SERVICE BULLETIN

M1514 2021-02-11

M1514: 2020 SOFTAIL - CLUTCH RAMP RUNNING CHANGE

Figure 1. Clutch Actuation System - Ramp Kit

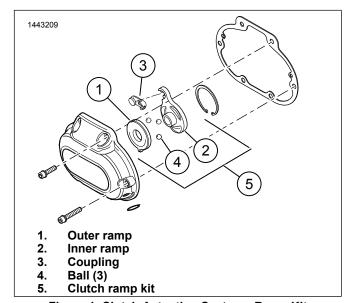
To inform dealers of a running change to the inner and outer ramp of the clutch actuation system in all 2020 Softails built on and after March 15, 2020.

See Figure 1. Harley-Davidson is creating a kit (Part No. 37000376) for this change.

Old 19° Part No.	Item Description	New 21° Kit No.		
37200261	RAMP,CL,INNER	37000376		
37200262	RAMP,CL,OUTER	37000370
